ADDENDUM #1

SUBJECT: Emergency Generator Installation at Woodson Food Services Warehouse (MMB-088-24)

**WOODSON FOOD
SERVICES
GENERATOR**

E601

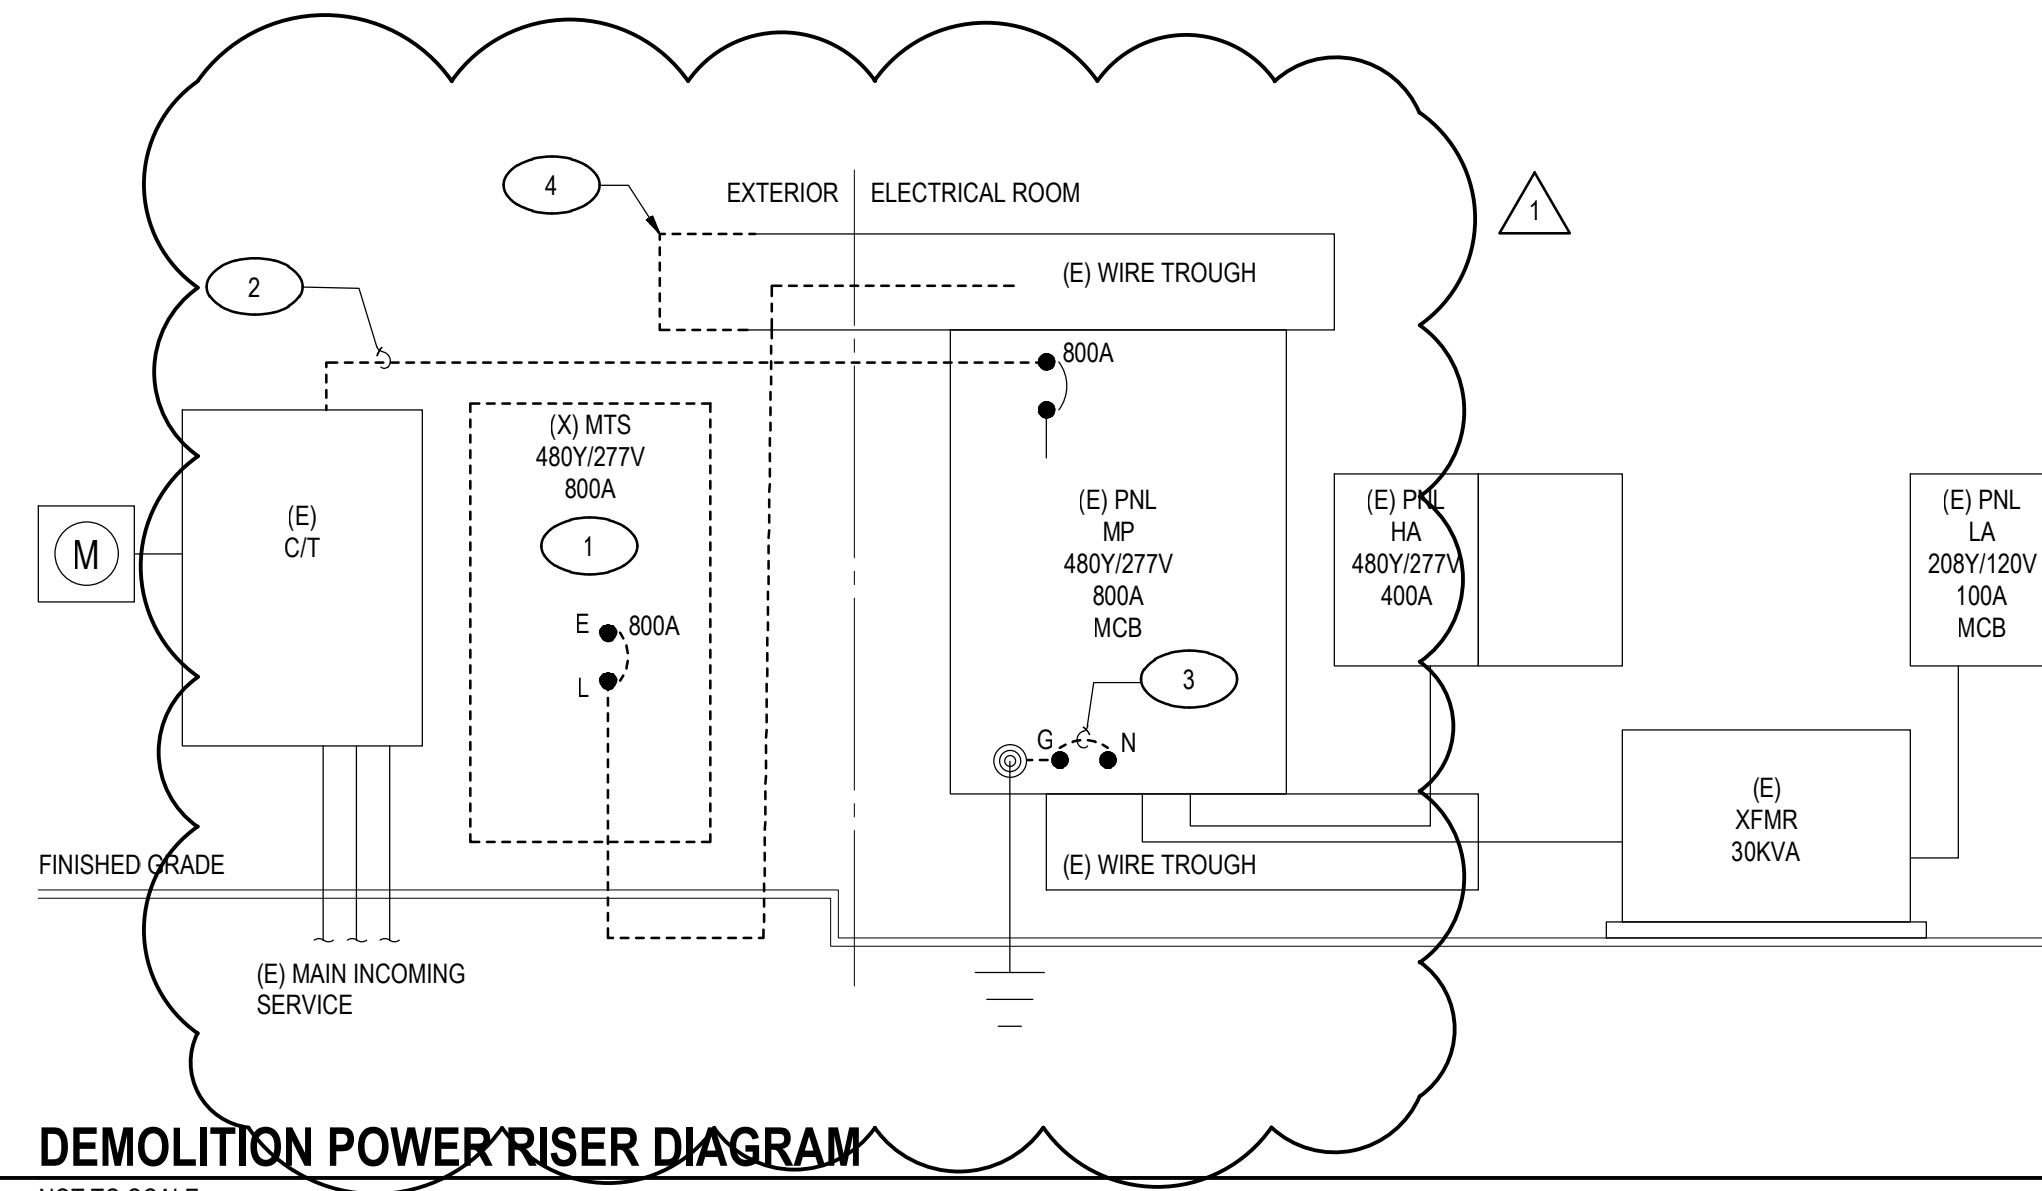
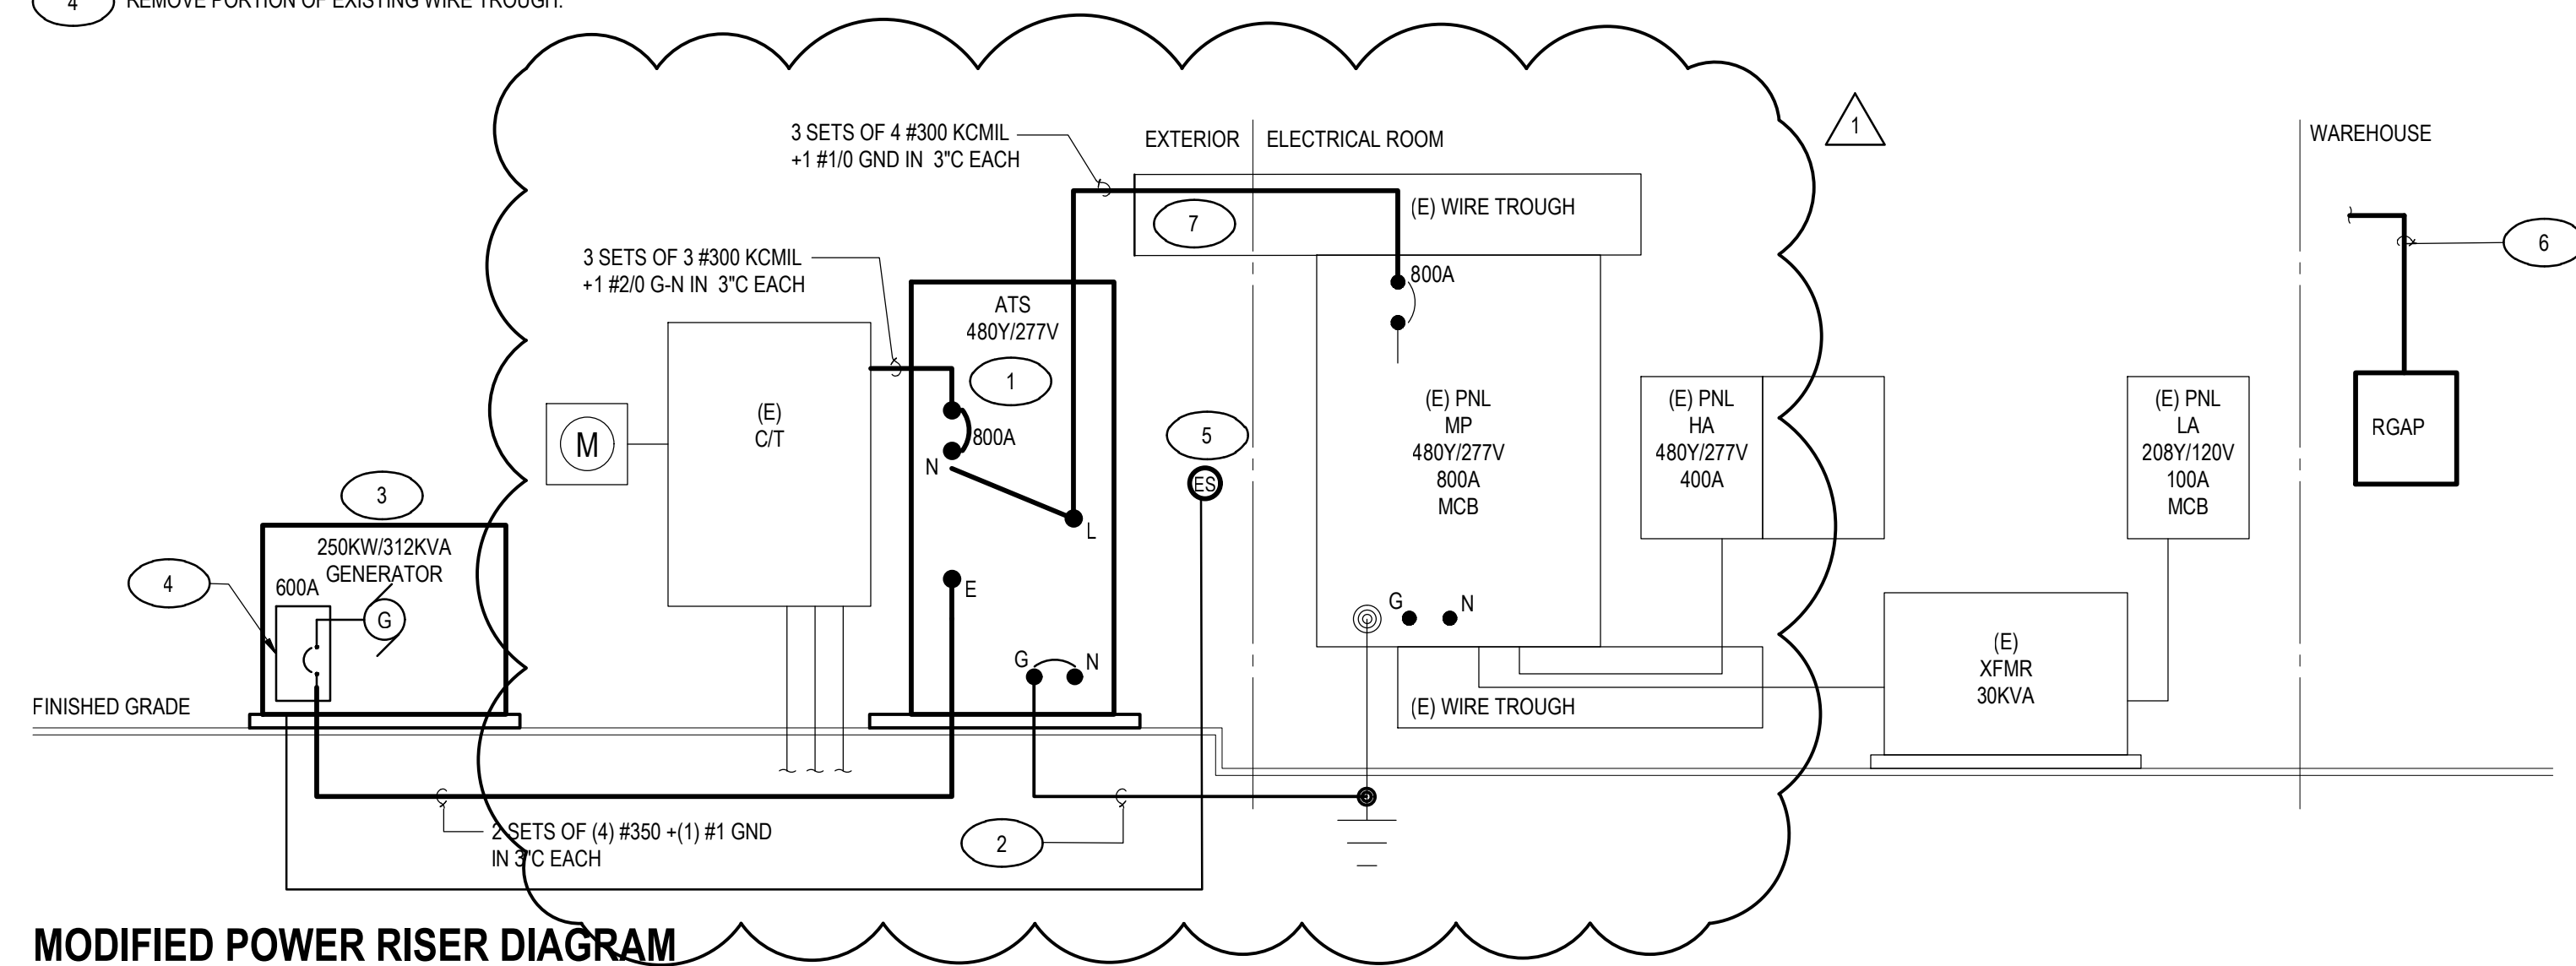
- Q1. Sheet E601 Detail 1 Demolition Power Riser shows the existing 3 sets of Conduit & Feeders to Existing MTS. The Conduits & Feeders do not exist. They go from an existing CT Cabinet to Panel and a Lockable Breaker.

- Q2. Do you want the contractor to re-route 3 sets of (4) 300 KCMil, (1) #2/0 Ground in 3" Conduit from existing CT to New ATS? In turn the existing load side wire from MTS(X) to be used as load side for New ATS appear not to be long enough to reach the Main Breaker in Panel MP. Do you want these Feeders extended or replaced with no splices?

The drawings do not show the actual configuration for this project. The exterior pad mounted equipment is not a MTS as the drawings show. It is essentially a switchboard section with an 800A breaker KIRK keyed in with Panel MP main breaker. The drawings mistakenly have the service feeders shown to the "MTS" and the load leaving the "MTS" to the Panel MP. The "MTS" actually only has one feeder to Panel MP. The service feeder goes directly to Panel MP.

- A1&2 Yes, incoming normal power feeders will need to run from existing CT to new ATS [3 SETS of (3) #300 KCMIL+(1) #2/0 G-N IN 3" C]. Then new feeders from the load side of new ATS to existing panel MP. See attached revised E101 and E601.**

A6. See attached revised E101, E501 and E601. The generator pad size will need to be coordinated with the purchased equipment, once submittal approved, as indicated on drawings. That will be on the contractor to coordinate during construction.
